Alexandria City Hall

South Façade Colonial Revival Detail Restudy Recommendations

BAR Hearing 10/16/25

APPLICANT PROPOSAL: ALT 1 MODERNIZATION APPROACH

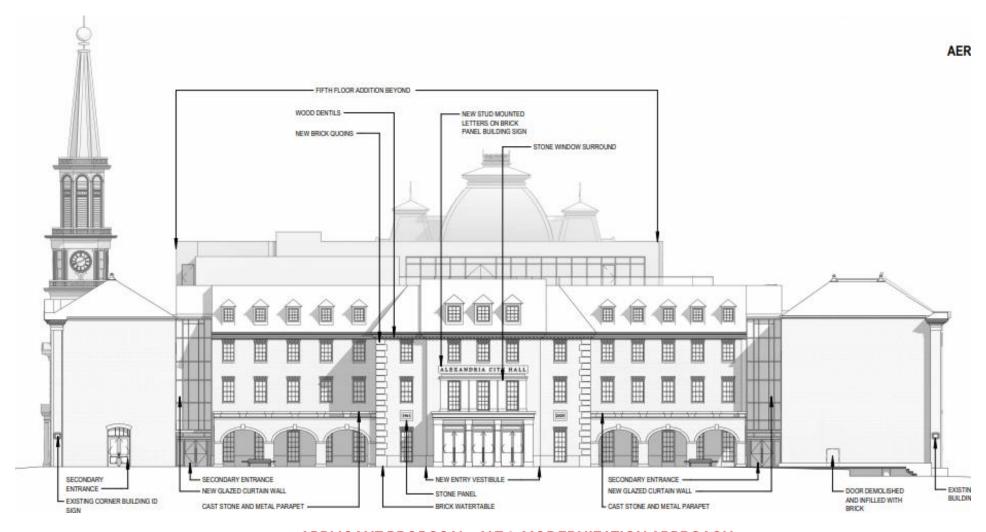
The raised roof above the new projecting entrance is inappropriate for a Georgian style building and creates unnecessary complexity in the traditional hip roof form. The new chimneys are in an awkward and untraditional location. The windows, and particularly the dormers, on the wings of the main block are visually crowded. The pilasters flanking the entry doors do not have classical proportions and appear to extend thru the entablature to the cornice. The quoins should have greater difference in widths, as shown on the Carlyle House and Christ Church. The new brick watertable cuts through the windows, which is not historically appropriate. The arcade makes absolutely no architectural sense on this facade. It will be expensive to construct and is shown with a "green" roof that will be difficult to maintain and visible to very few building occupants and the environmental benefits will be de minimis. While the vertical hyphens separating the 19th and 20th century portions of the building are welcome, why are they glass with a view of the fire stairs? This curtain wall should be something opaque that references other portions of the building, like slate or metal panels.

APPLICANT PROPOSAL: ALT 2 MODERNIZATION APPROACH

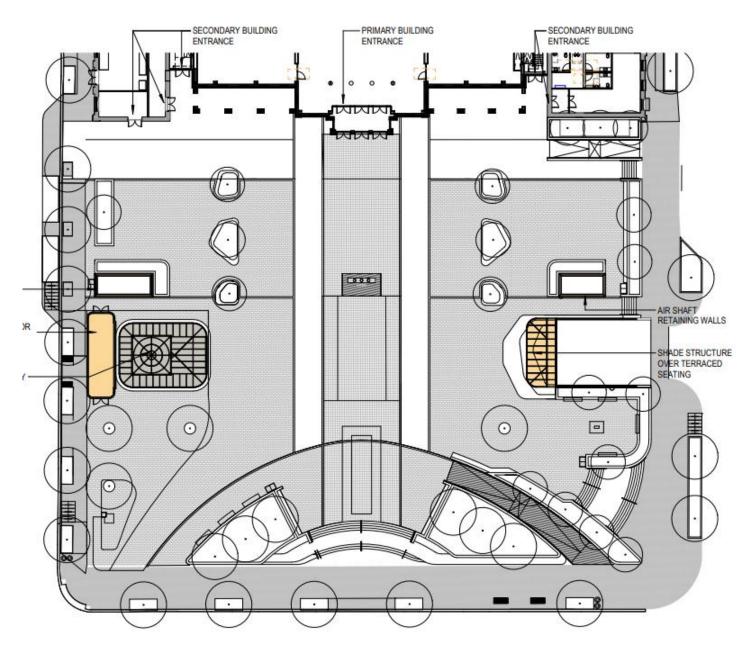
In addition to the comments in ALT 1, the pilasters of the second-floor stone surround do not have a capital or entablature and do not align with or relate to the first-floor entry vestibule.

The stone panels at the second-floor spandrel are characteristic of the later Adam or Federal style and inappropriate to the Georgian Revival style of this façade.

APPLICANT PROPOSAL: MARKET SQUARE

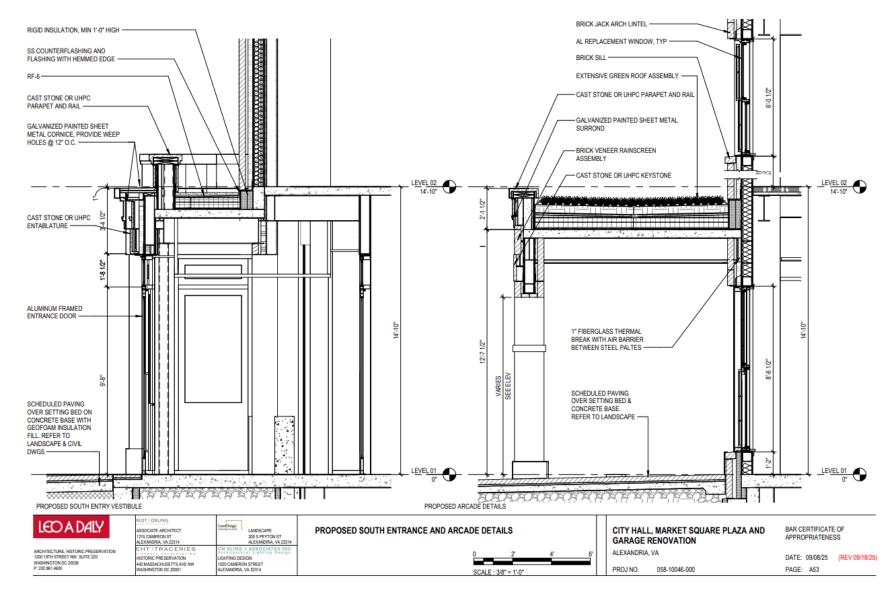
The irregular shape of the six new Mid-century Modern style planters and terraced seating platform are inappropriate to the formal and orthogonal Colonial Revival style of Alexandria.

- 9. Make the terraced seating platform and planters in Market Square orthogonal in a simple Georgian style.

APPLICANT PROPOSAL: ENTRY AND ARCADE SECTIONS

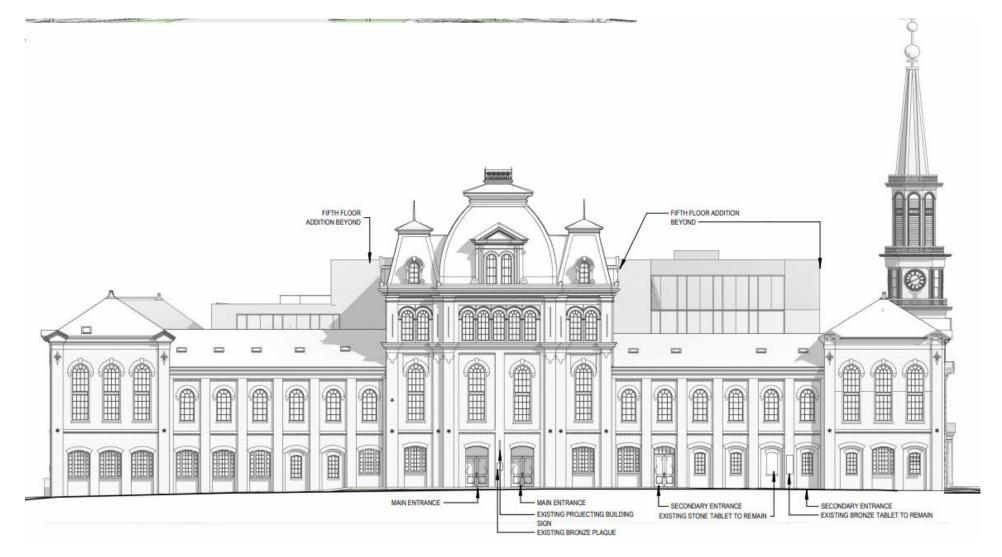
Pilasters at the building entrance extend inappropriately thru the entablature to the cornice and the pilaster base and capital are not correctly detailed.

The "balusters" above the entry are out of scale and lack appropriate detail.

The green roof of the pointless, reconstructed arcades will be expensive and difficult to maintain and are not visible to the public.

ALTERNATE SOUTH FAÇADE

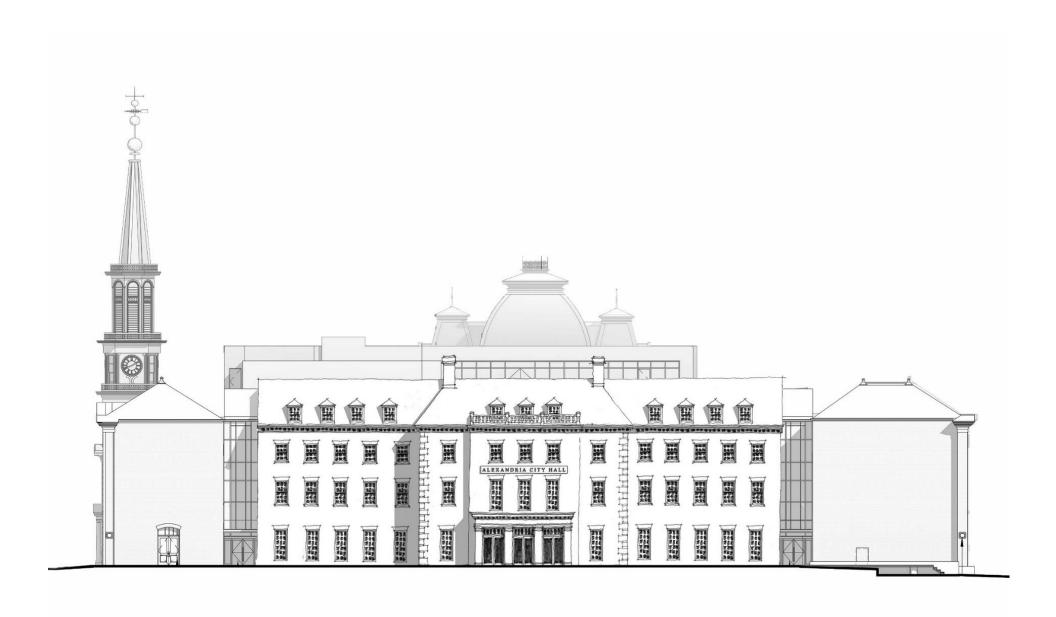
Recommended for Restudy

- 1. Remove the proposed shed roof form from the center of the hip roof and replace it with a flat roof and ornamental railing with plinths on the cornice above the projecting entrance feature.

- 2. Replace the two existing brick chimney forms in the appropriate scale, shape and location on the central hip roof.
- 3. Revise the detailing of the projecting entrance feature to be classically appropriate to the Colonial Revival style found in Alexandria. Refer to Andrea Palladio's Four Books of Architecture (Ware edition 1738); Sebastiano Serlio's Five Books of Architecture (English ed. 1611); or William Ware's The American Vignola (pub. 1903), etc. for the correct classical proportions and details of columns, entablatures, etc.

- 4. Study making the quoins, jack arches, entry pilasters, entablature and the balustrade of limestone or cast stone to give primary architectural prominence to the central building mass.

- 5. Increase the differentiation in width between courses of the quoins to properly represent header and stretcher courses.
- 6. Delete the proposed brick watertable that intersects the first floor windows and delete the existing ogee brick projection at the second floor, as it conflicts with the proposed quoins.

- 7. Remove the proposed non-functional flat roof arcades on the wings.
- 8. Make the glass wall of the exit stair hyphen an opaque material, like slate or metal panels, so that the illuminated fire egress stair behind is not visible from Market Square.

- 1. Reduce the height of the windows as the height of the building increases.
- 2. Respace the windows on the flanking wings to provide more exposed brick and visual mass at the east/west corners of building.
- 3. Raise the roof of the main body of the building so that there is more room for a pronounced decorative cornice and more exposed brick between the lintels of the top windows and the cornice. Conversely, make the third floor windows slightly shorter.
- 4. Provide a continuous cornice with modillions or dentals appropriate to the Georgian style.
- 5. Rearrange the location of the dormers on the wings to align between the windows below to simplify the roof.
